## Cylinder Head Gaskets

### Cylinder Head Gaskets

Item	Description
1	Pre-1997 Model Year F-250-450
2	1997 Model Year F-250-450

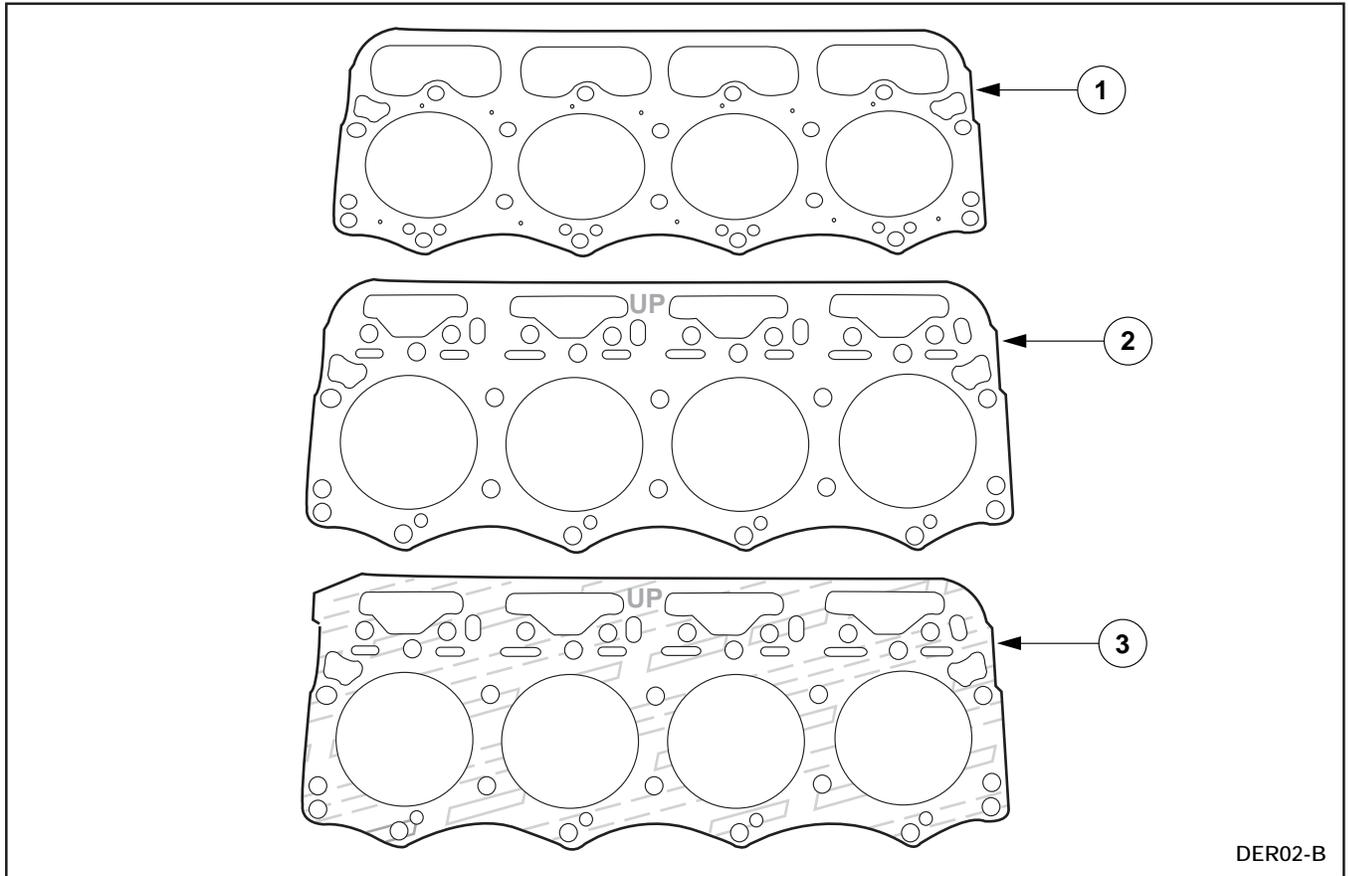
- The cylinder head gaskets, from the model year 1997 and forward, have individual push rod holes that guide the push rod to the center of the lifter.
- The new cylinder head gaskets have the word UP painted on them.
- The new cylinder head gaskets may be used on all previous engines, but the pre-1997 gaskets cannot be used on the newly designed engines.
- The new cylinder head gaskets having the word UP on them as well as blue stripes running diagonally across the top, are used only on the F-650/750 models.
  - This thinner gasket can be used due to the lower rpm operating range of the F-650/750.
  - The outer corner of the gasket is visible while the engine is assembled.
